Addendum No. 5

RFP Number: 26-T003

Title: North Texas MOVES BUILD GRANT- TRE Double Tracking Construction Project

This Addendum is issued to answer the submitted questions. ****Answers are in RED****

FIGURE 1

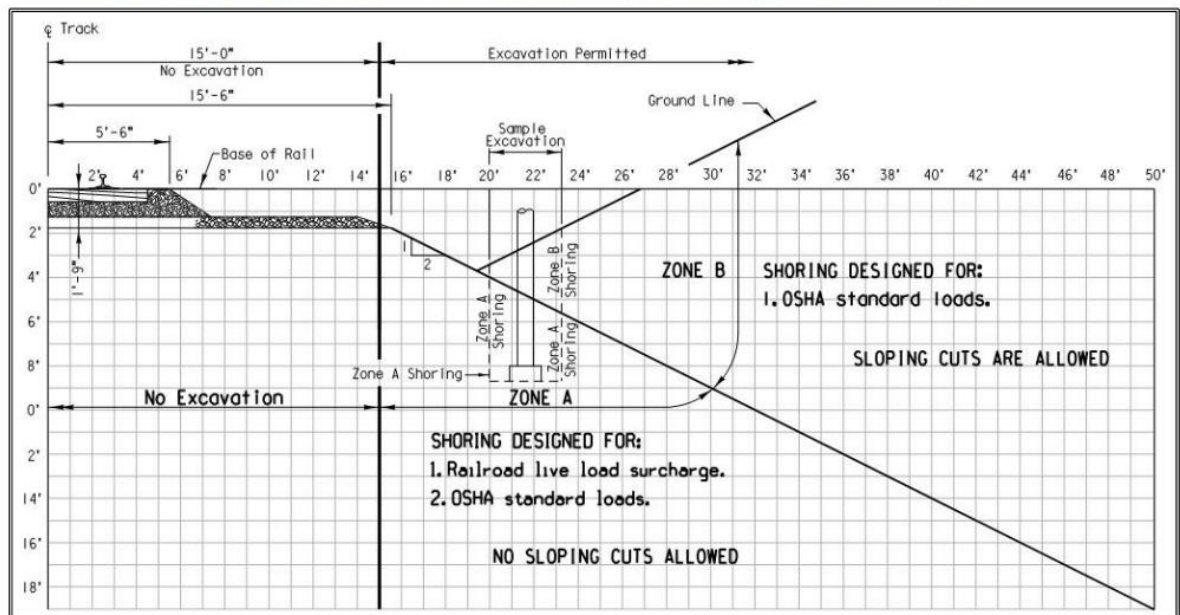
1. Can you please provide your requirements for the zone of influence specifically in relation to the proposed walls (and temp shoring needed to install the permanent walls)? Using the provided cross sections, it appears the temporary shoring required could have a potential to increase depending on what the requirements are for the zone of influence. —

Zone of influence from UPRR & BNSF Guidelines for Temporary Shoring.
